**LAS VIRGENES MUNICIPAL WATER DISTRICT
SCADA Communications Upgrade Phase 1**

ADDENDUM NO. 1

October 8, 2014

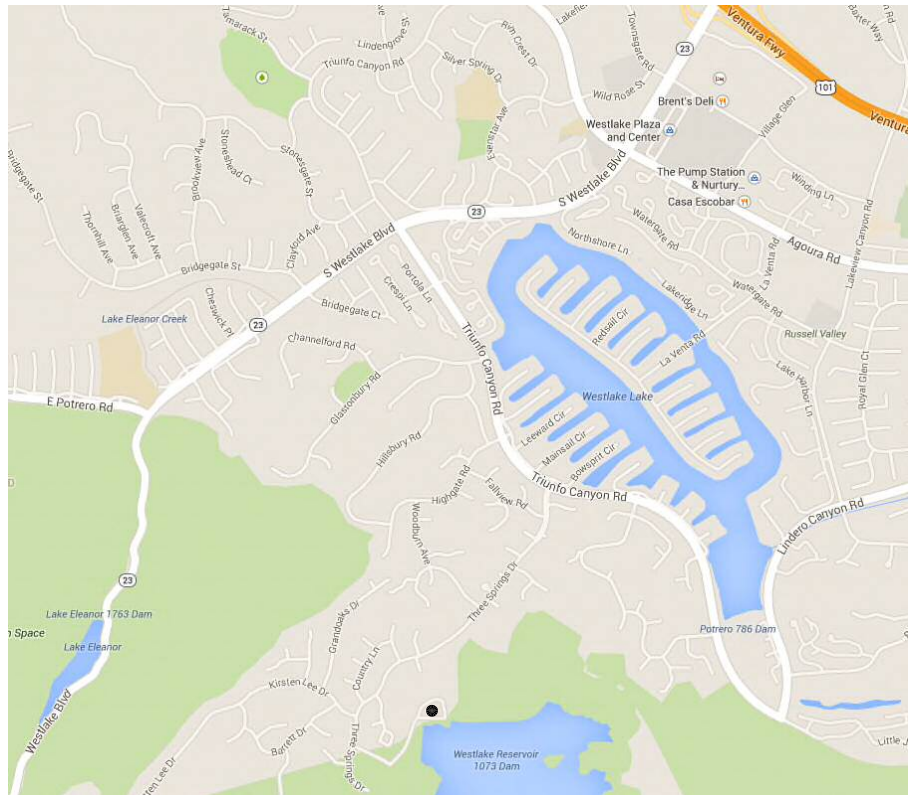
3. Question: Specification Section 01011- 1.1-14 (page 4) describes magnetic mounts for Calabasas tank however; drawings do not indicate magnetic mounts for this site. Are any magnetic mounts or related engineering required for this site?

Answer: The antenna mast will be mounted to the existing hand rail as shown on sheet 1422-15.3 and a magnetic mount tripod will not be required. Calabasas Tank is being rehabilitated and the contractor doing the work will be providing mounting studs as shown on sheet 1422-15.3. The studs being installed are intended to provide for mounting of conduit and solar panels.

SHEET 1 OF 1
DRAWING No. 1422-4.1
JOB No. 1422
SCALE: NONE
UNLESS NOTED OTHERWISE
BY A SPECIFIC DETAIL

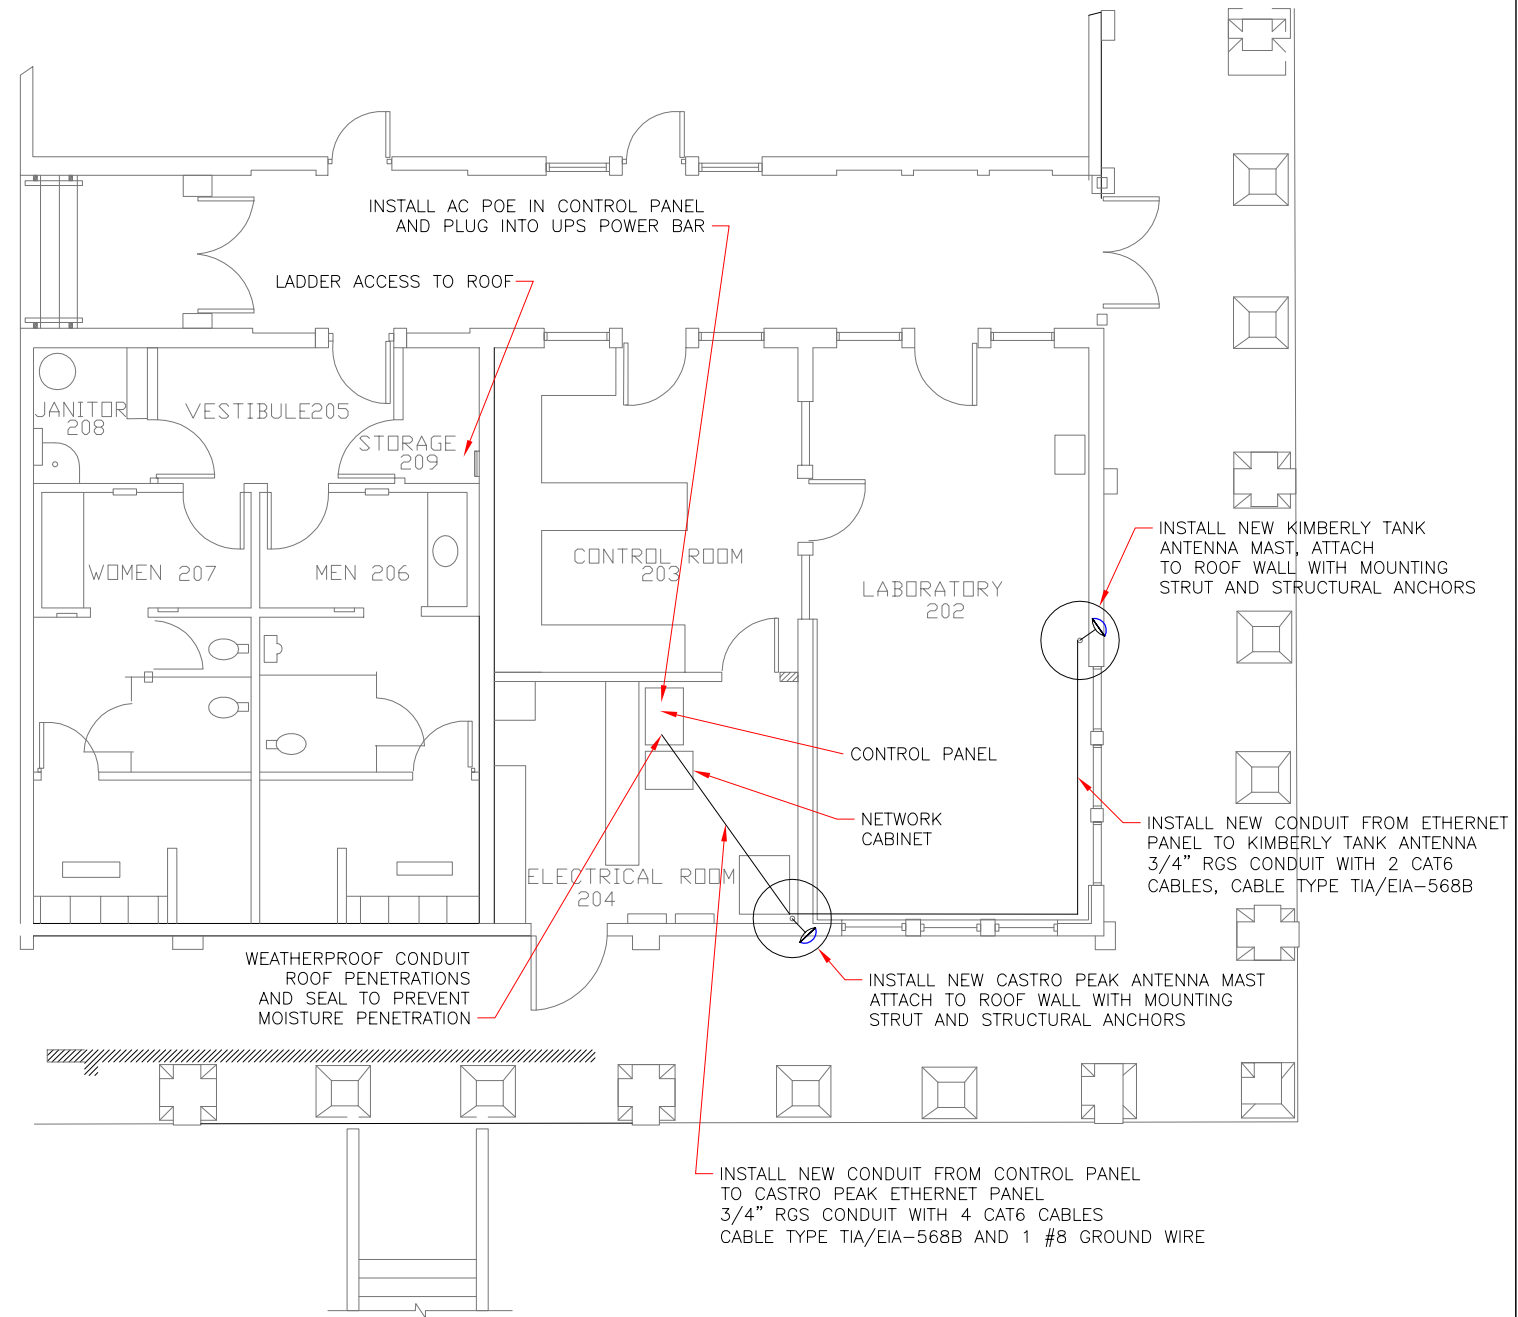
3. Westlake Drawing 1422-4.1

Antenna mast details, Ethernet panel and Panel Parts List shown on Drawing 1422-4.1 are not correct and should be removed from Drawing 1422-4.1. The details and parts are shown correctly on Drawing 1422-4.2. Please refer to revised sheet 1422-4.1 along with 1422-4.2 (attached)
